Subject: Communications Report Transmittal #13
Comanche Peak Steam Electric Station
Independent Assessment Program - Phase 4
Texas Utilities Generating Company
Job. No. 84056

Communications Report

Figure A-1

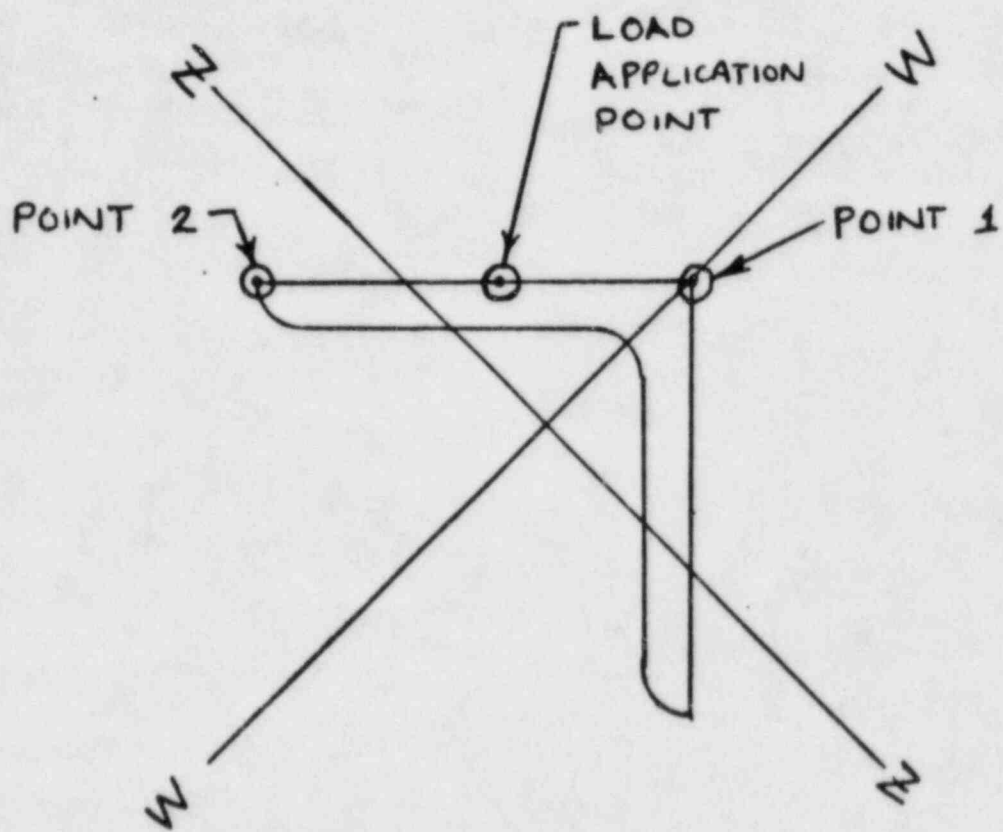
3.	<p>In-plane Angle Braces for Trapeze Type Cable Tray Supports.</p> <p>Per Reference 1, Gibbs & Hill checked on the working point analysis of the C₃ type supports and found that the largest axial load for a single angle brace was 7.46 K. The evaluation of the brace appears in Attachment 1. The results of the evaluation show the brace to be acceptable.</p> <p>Status: Closed.</p>

Project	TEXAS UTILITIES	Prepared By	J.P.R.	Date	27 OCT 84
Subject	ATTACHMENT A	Checked By	-	Date	
System		Job No.	84056	File No.	
Analysis No.		Rev. No.		Sheet No.

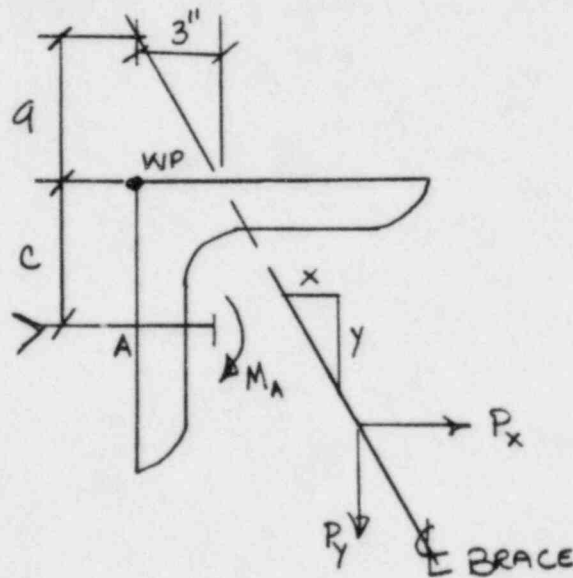
2.	<p>Effect of CMC 6187 on SP-7 with Brace Type Supports.</p> <p>Cygna asked whether CMC 6187 had been incorporated in the generic designs of SP-7 with brace type supports. Calculations appear in Attachment 1 which show an overstress in the brace for one possible support configuration.</p> <p>Gibbs & Hill suggested that the calculation was conservative because the axial rigidity of the support-tray system would lower the frequency and hence the accelerations. They also stated that the tray load is applied at two points along the beam which will reduce the brace axial load. Employing reduced accelerations due to support tray frequency and a distribution of the load along the beam, the interaction was calculated as 0.8. (Calculations shown in Attachment 1). Though these hand calculations appear to show no technical problem, Cygna still feels that because the conditions shown in the CMC weren't considered in the original</p>
